**MONTGOMERY COUNTY HISTORIC PRESERVATION COMMISSION**  
**STAFF REPORT**

<b>Address:</b>	8000 Overhill Rd., Bethesda	<b>Meeting Date:</b>	10/23/2019
<b>Resource:</b>	Contributing Resource <b>Greenwich Forest Historic District</b>	<b>Report Date:</b>	10/16/2019
<b>Applicant:</b>	Amil Gupta Mark Kramer, Architect	<b>Public Notice:</b>	10/9/2019
<b>Review:</b>	HAWP	<b>Tax Credit:</b>	n/a
<b>Case Number:</b>	35/165-19-D	<b>Staff:</b>	Dan Bruechert
<b>PROPOSAL:</b> Porch Enclosure

## SINGLE FAMILY DETACHED HOME - EXISTING PORCH ENCLOSURE

*Figure 1: 8000 Overhill Rd., Bethesda.*

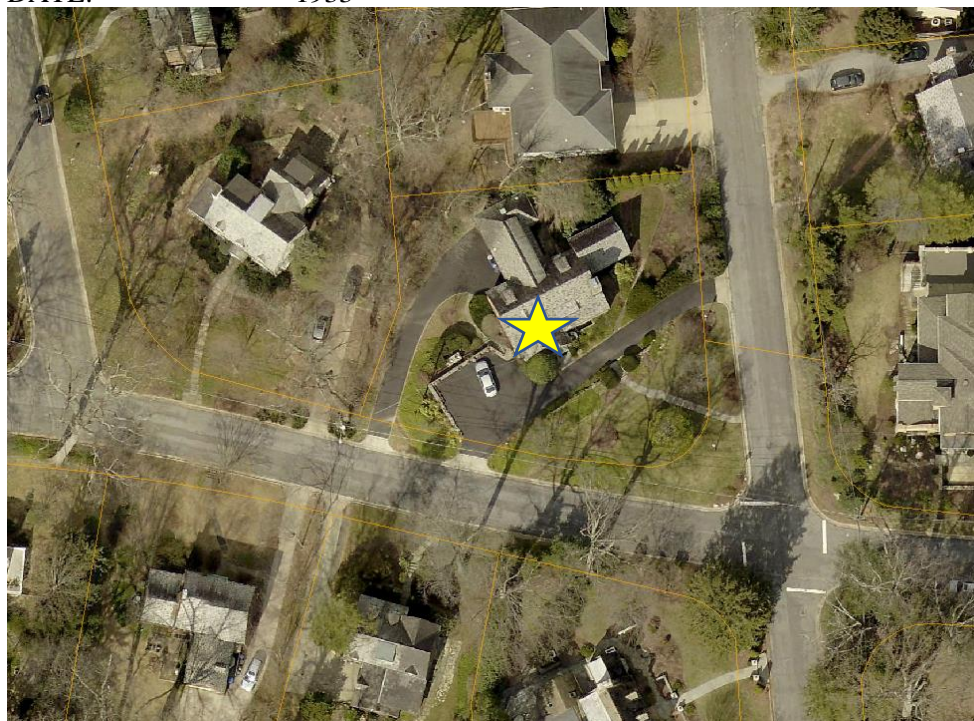
The applicant proposes enclosing the existing right side-gable screened-in porch. The existing porch is constructed with rough-hewn timber, with arched corner brackets, and a slate roof. Staff finds these elements to be character defining features of this resource and of Tudor Revival architecture in general.

SHEET TITLE:  
EXTERIOR ELEVATIONS

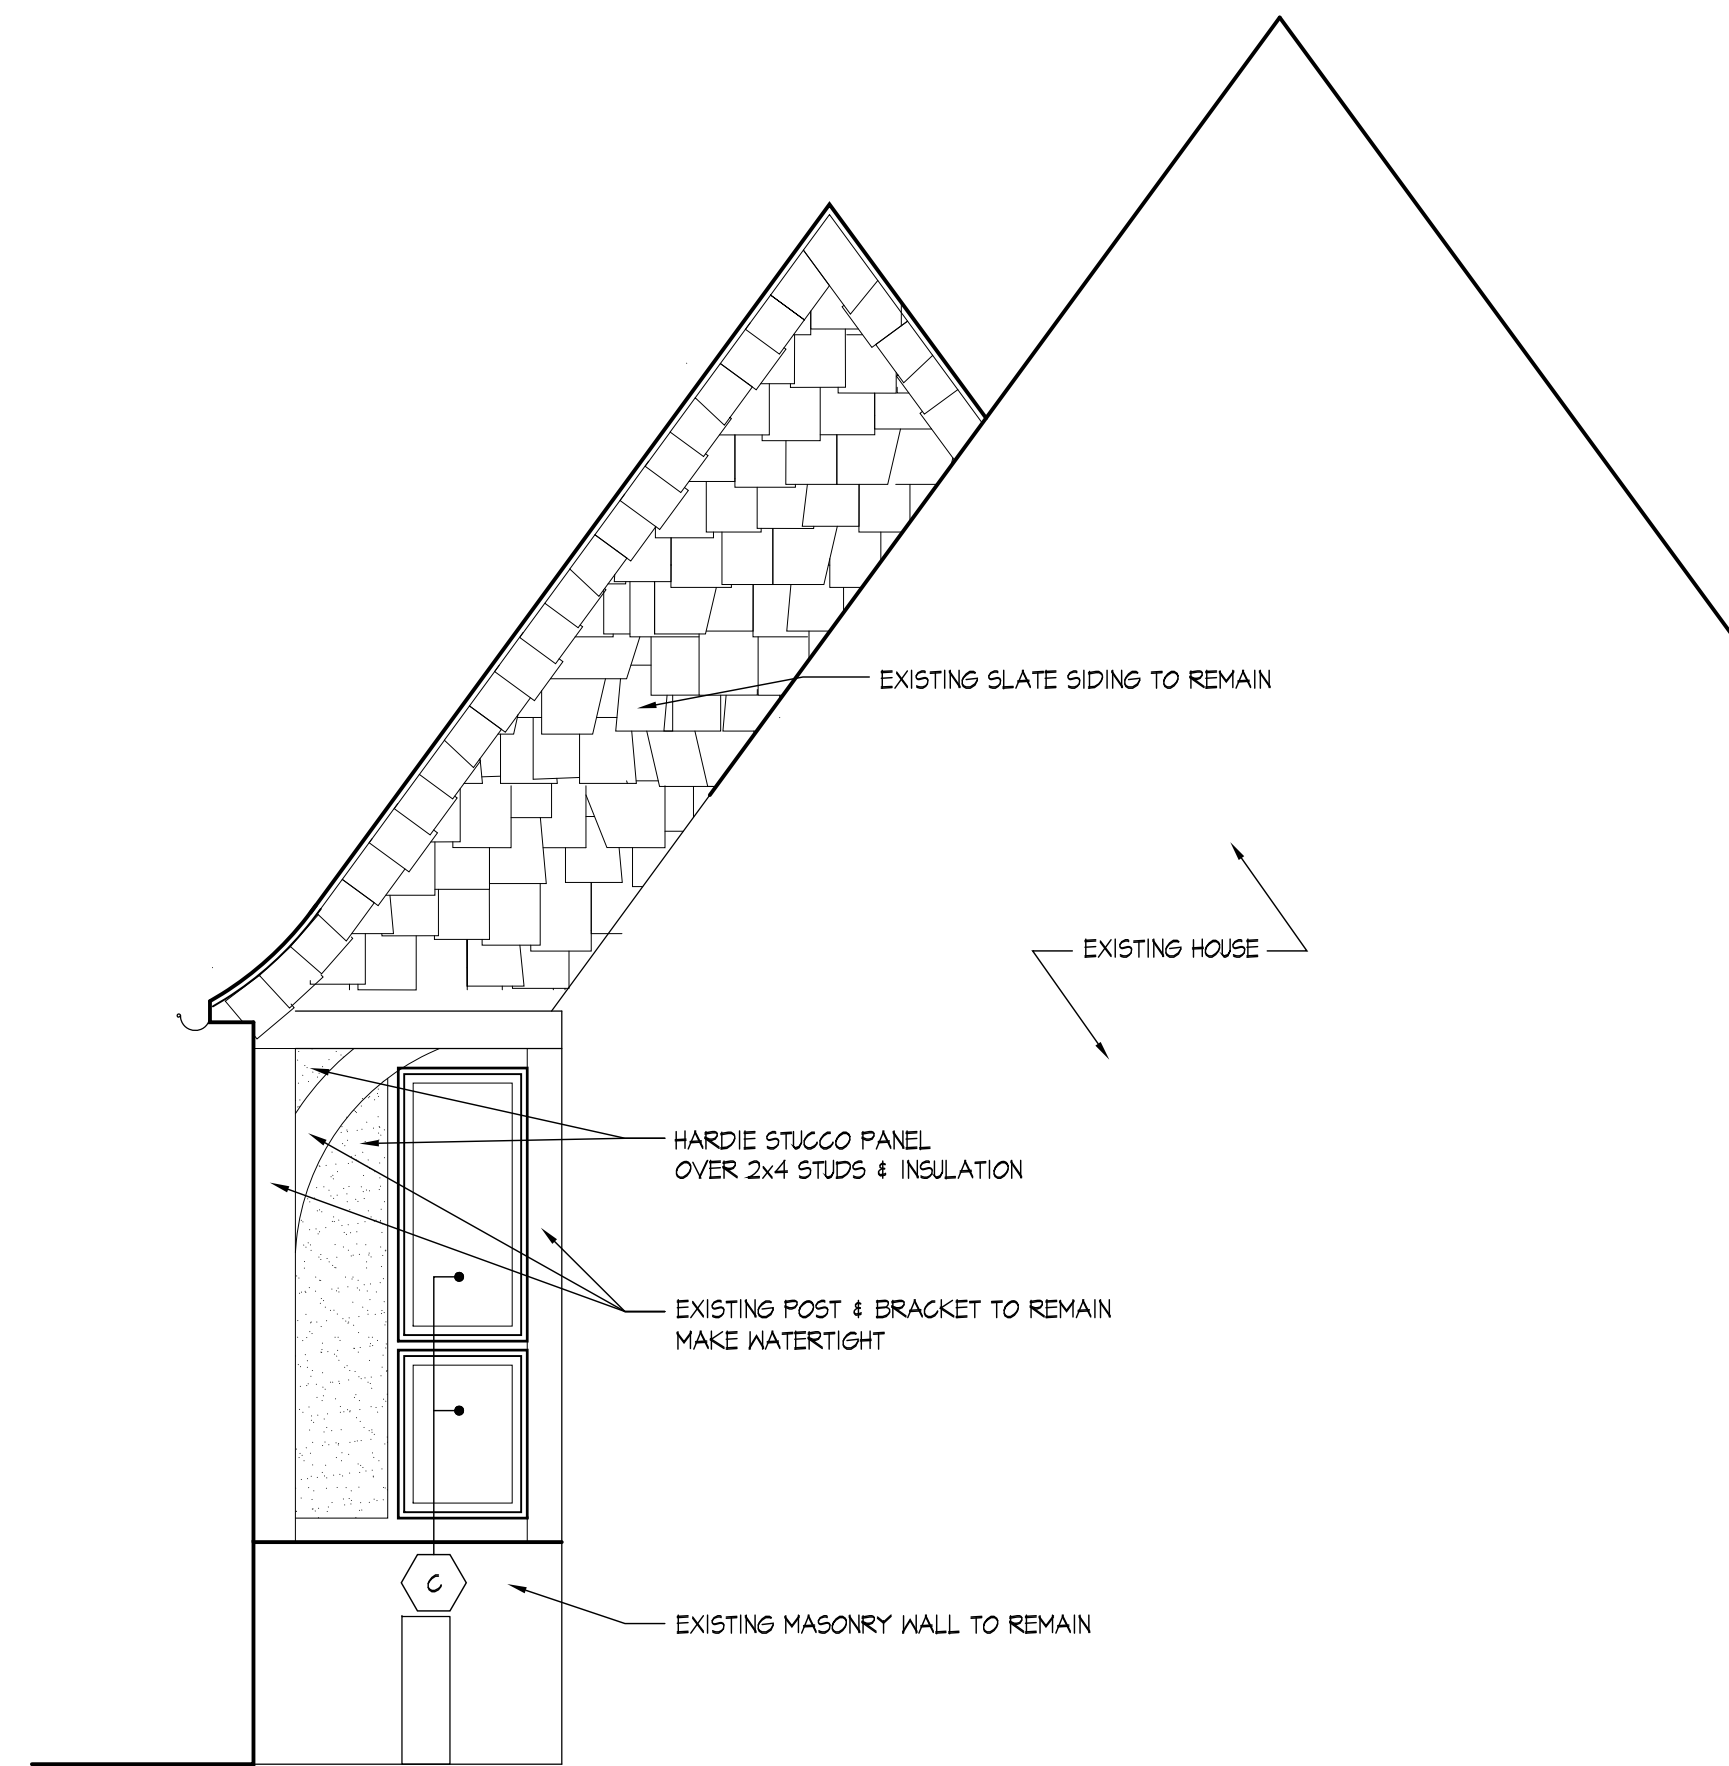
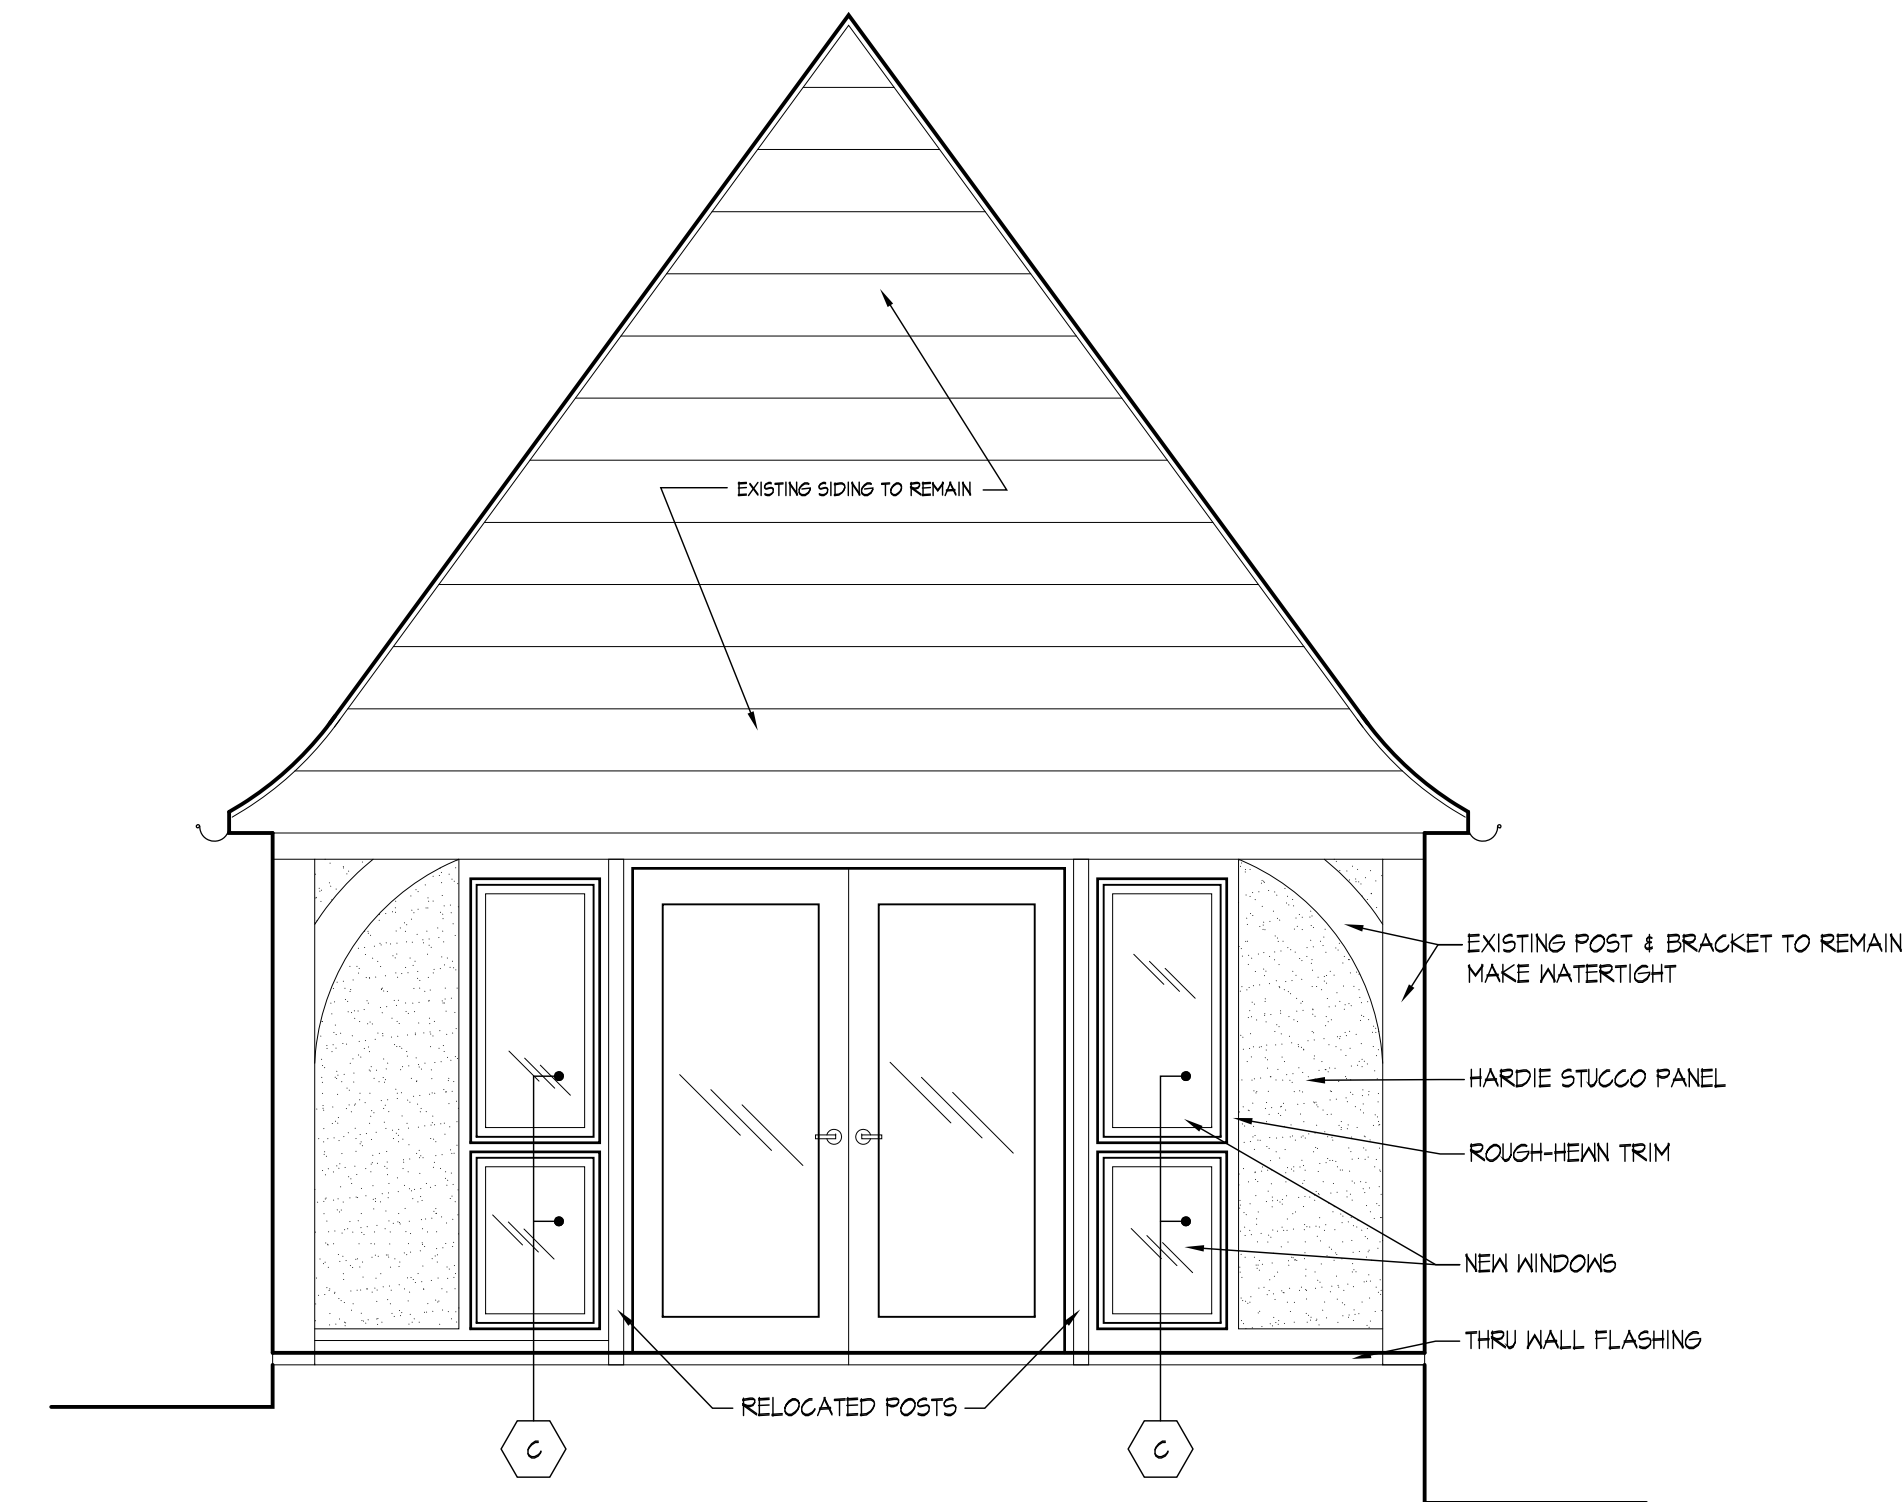
The applicant proposes to enclose the existing porch with a combination of Marvin windows, matching

the frame details of the approved replacement windows,<sup>2</sup> and stucco fiber cement panels. The proposed window configuration consists of four low, fixed windows with two larger casement windows above in each of the two bays on the north and south elevation. The east elevation will have a pair of French doors, flanked by fixed sidelites and fiber cement stucco panels. The fiber cement panels will be inset so that they are behind the existing post and brackets, leaving the original structure exposed. Additional structural elements will be constructed on the interior of the porch. While there is no stucco on the porch in its current configuration, this treatment is present on limited areas elsewhere on the house. Stucco is a material commonly applied to Tudor Revival style architecture, and its inclusion on the side porch will not introduce a new material to the building or the District (see Fig. 2, below).

alteration that the *Design Guidelines* envisioned would be approvable under many circumstances with the appropriate application of design review. In short, should the HPC allow the applicant to enclose the porch and remove the existing, historic, post and brackets; or should the HPC allow for the enclosure of the porch with some fiber cement panels and retain all of the existing historic post and brackets?

In determining the preferred outcome for a porch enclosure, the Greenwich Forest *Design Guidelines* (D10) don't provide explicit guidance, aside from stating that the HPC is responsible for ensuring that the enclosed porch is "compatibly designed" and that the significant architectural features are preserved. The *Standards* (particularly 2 and 5) offer a bit more guidance by stating that the historic character of the house should be retained and that distinctive materials, construction techniques, and/or examples of craftsmanship that characterize a property will be preserved. Staff's finding that post and brackets are distinctive, character defining features, and this interpretation of the *Standards* strongly encourages their retention in any alteration. Staff finds that under the current proposal the character defining post and brackets will remain visible from the public right-of-way.<sup>3</sup>

Staff further finds that there are only two ways that would allow for the enclosure of the porch while retaining these elements. First, the applicant could install large windows behind the post and brackets. This would retain most of the existing, open appearance with only the addition of the window division. Staff, in fact, recommended this as a potential design solution. The architect responded under this proposal there would not be sufficient bracing to satisfy the window load requirements and it was infeasible. The second method of enclosing the porch is the one presented in the application. The current proposal will retain the historic, character defining features and introduce sufficient structural members to ensure the porch's retention as an integral part of the historic building.

Furthermore, we have left the exposed timber construction on the exterior and are using stucco to fill in the spaces which will be left over after the windows have been installed.
